A/KTN/111

Comprehensive Analysis: Statutory Planning Mechanisms and Land Allocation for Kwu Tung North Areas 32 and 34 in Relation to Planning Application No. A/KTN/111

Re: Comments on S16 Planning Application for Proposed Minor Relaxation of Plot Ratio and Building Height Restrictions for Proposed / Permitted Private Housing Development and Proposed Public Transport Terminus, Shop and Services and Eating Place within a Permitted Private Housing Development at Planning Areas 10NW (incl. FSSTL No. 307), 13E, 14W, 14S (FSSTL No. 297), 16NW, 16NE, 16SW and 16SE of Fanling North New Development Area; Planning Areas 20E, 25E, 14, 22W, 22E, 26W, 26E, 15N, 15C, 15S, 23N, 23C and 23S in Kwu Tung North New Development Area, New Territories
(Application No. A/KTN/111)

4. Proposed BH for the Subject Site is Not Aligned with the Surrounding BH Context and Stepped BH Profile in FLN NDA

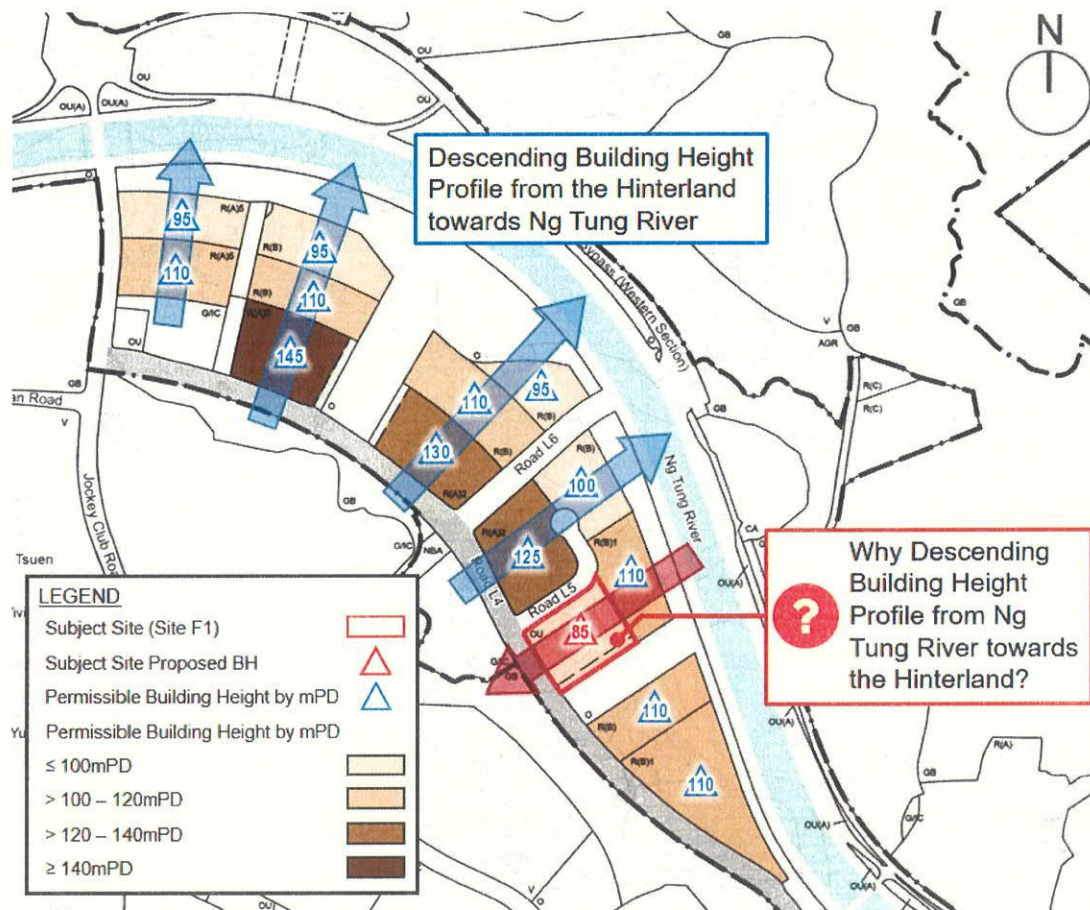
With specific reference to the Subject Site (i.e. Site F1), the proposed BH of 85mPD for the Subject Site under the captioned application does not appear to be aligned with the planned BHs of the surrounding developments sites, particularly given that the permissible BHs of nearby sites have been increased to 100mPD, 110mPD and 125mPD respectively under the latest OZP amendment (for the pilot area of large-scale land disposal in FLN NDA) and the previous planning approvals. The proposed maximum BH of only 85mPD for the Subject Site is substantially lower than that permitted for its surrounding sites and fails to materialize the stepped BH profile concept (i.e. descending BH profile from the hinterland towards Ng Tung River) as intended under the current FLN OZP. In particular, some of the adjoining development sites located near the riverside promenade have a higher maximum BH than that permissible for the Subject Site, notwithstanding that the Subject Site is located further inland. Such BH arrangement does not appear to be logical or consistent with intended stepped BH profile, in which BH of the development sites at the hinterland should be generally higher, and with BH gradually decreasing towards Ng Tung River.

The proposed BH of 85mPD for the Subject Site would therefore not only limit the design flexibility of the future development but also result in an inconsistent building height profile in relation to the surrounding development sites. It is considered that a more appropriate BH should be permitted at the Subject Site, having regard to its hinterland location, the BH of surrounding development sites, the overall stepped BH profile under the FLN OZP.

Moreover, upon our further review of the permitted BHs for the Subject Site and the proposed BHs as per CEDD's scenarios in the FI submission, we opine that the proposed BHs for the Subject Site should be revised as follows:-

Scenario 1 (with MiC only): Under JPN 8, for adoption of MiC, 4% increase of total building height is allowed. As such the revised building height should be **no less than 83.2mPD** (based on +4% of the existing 80mPD BHR under OZP).

Scenario 2 (with aboveground carpark only): under the approved GBP submission for the Subject Site, the storey height of the basement carpark is about 7m. As such, if aboveground carpark is adopted, the BH should be **no less than about 87mPD**.

Scenario 3 (with both MiC and aboveground carpark): incorporating the design elements above, the resultant BH for the future development under this scenario should be **no less than 90.2mPD**.
